400 Chestnut Street Tower II

In the Matter of the Application of) Docket No. 50-327
Tennessee Valley Authority)

REQUEST FOR ADDITIONAL INFORMATION

EVALUATION OF SPECIAL TEST PROGRAM

FIGURE 1

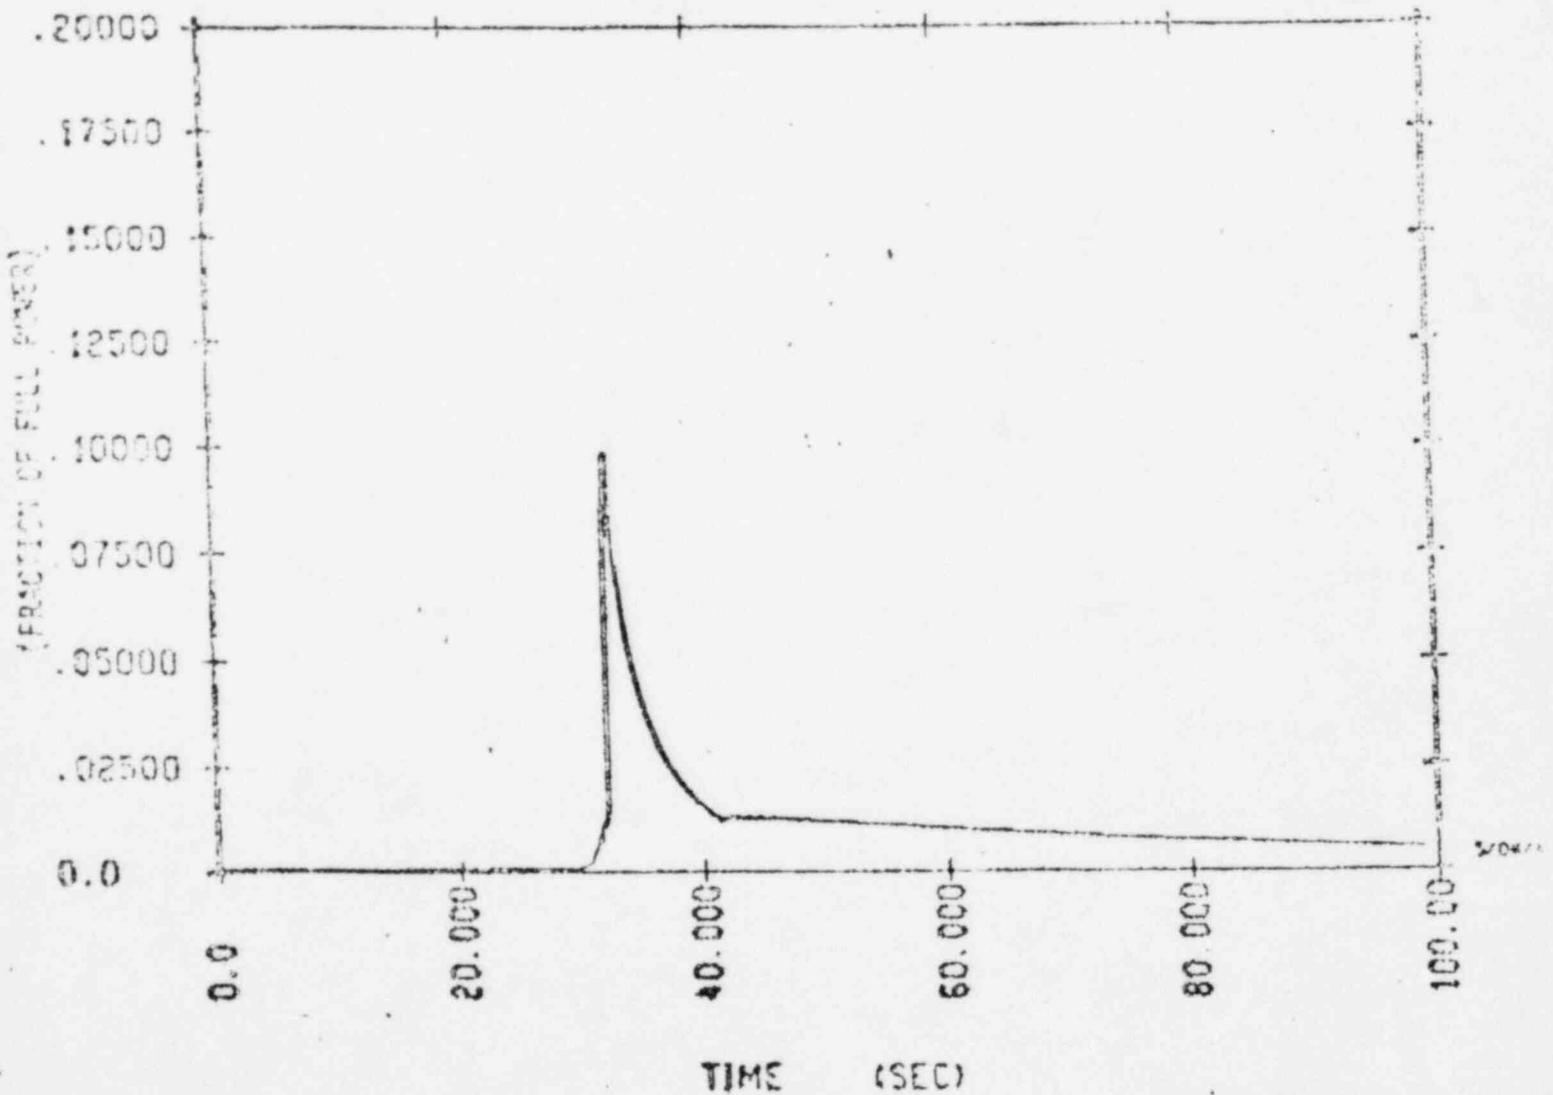
For the analysis described in Section 4.2.1, provide a figure of core heat flux versus time corresponding to Figure 4.2.1.

See attached Figure 1.

RESPONSE TO QUESTION 16
